NUCLEAR REGULATORY COMMISSION

Title:                   Advisory Committee on Reactor Safeguards  
                              Subcommittee on EPR

Date:                  Thursday, February 18, 2010

**Presentation to ACRS  
U.S. EPR™ Subcommittee  
Calvert Cliffs Nuclear Power Plant Unit 3  
FSAR Chapter 8  
February 18, 2010**

# Onsite Power Systems

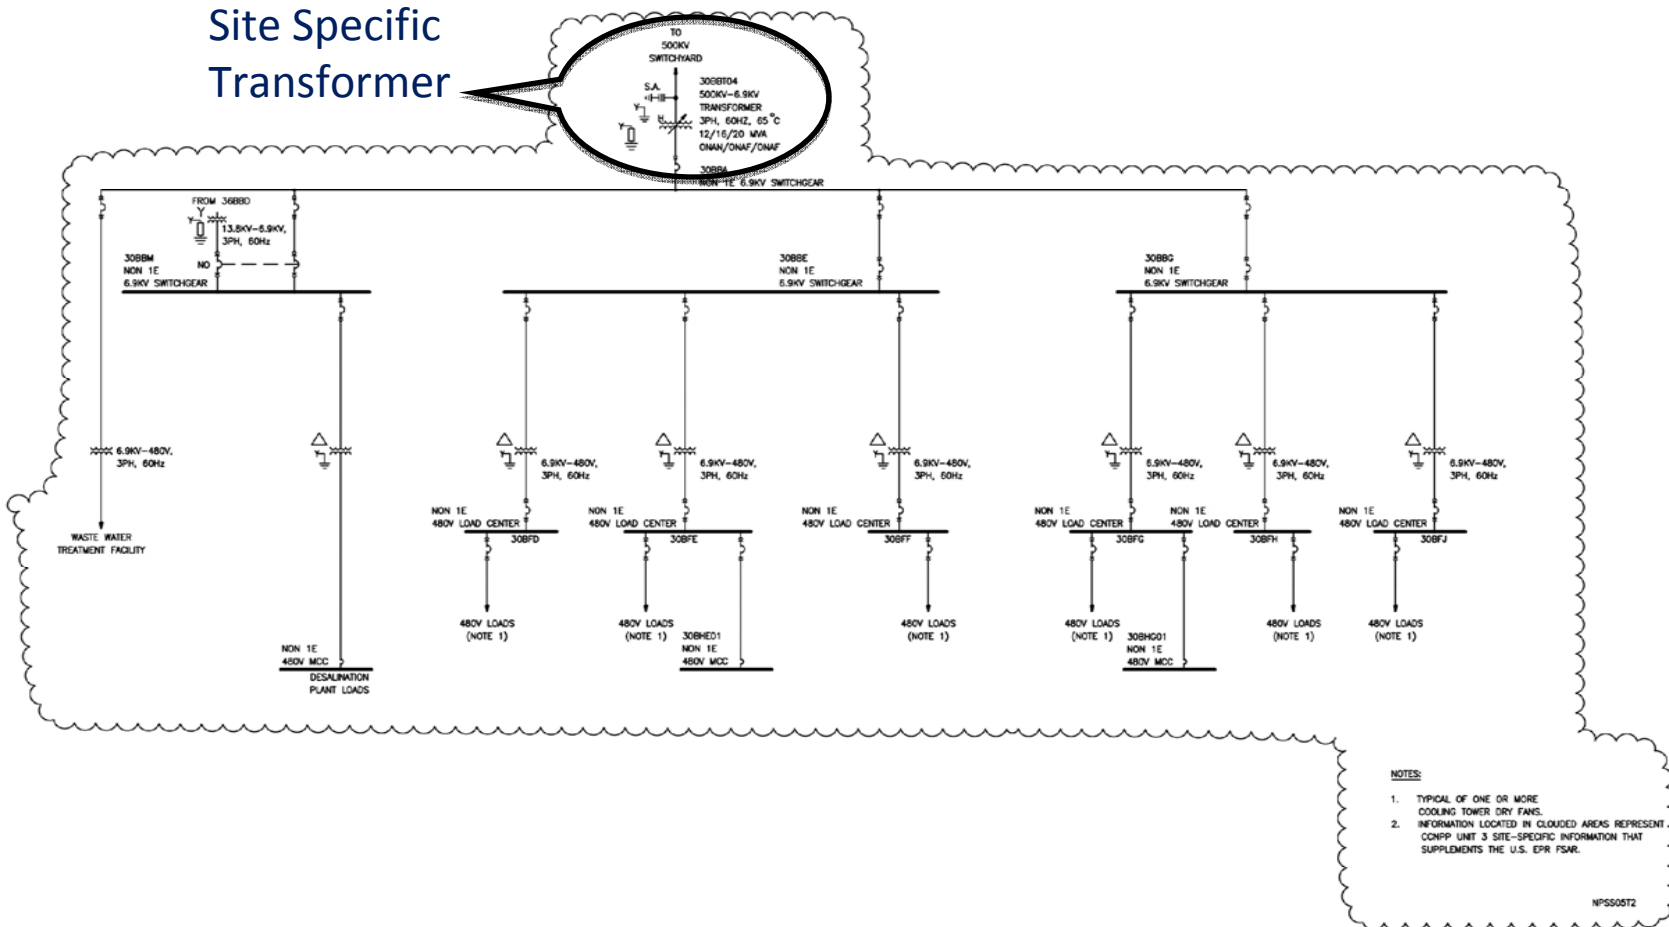
3 I am glad you have this drawing up there.

4 That alternate feed comes up to Bus  
5 36BBD, I think. Right, that is an in-plant power  
6 block NPSS bus.

8 MEMBER STETKAR: It seems that that feed  
9 was added fairly late during the design process. It  
10 does not show up on all of the drawings in the FSAR.

8 MEMBER STETKAR: Yes, it is not. I don't  
9 have the figure numbers, but go back and check them.  
10 It doesn't show up on all of them.

5 MR. PEACH: And it should show on all the  
6 figures. It should be consistent across all the  
7 figures.

17 I have a September 25th, 2009, letter, in  
18 response to an RAI, related to the question you had  
19 about the backup transformer. In here, they added  
20 the additional load in. So, we have the backup power  
21 scores for the desalinization plant and the  
22 demineralization plant that are on there.

23 So, there is a figure that also shows it.  
24 The figure that you have on there is not the latest
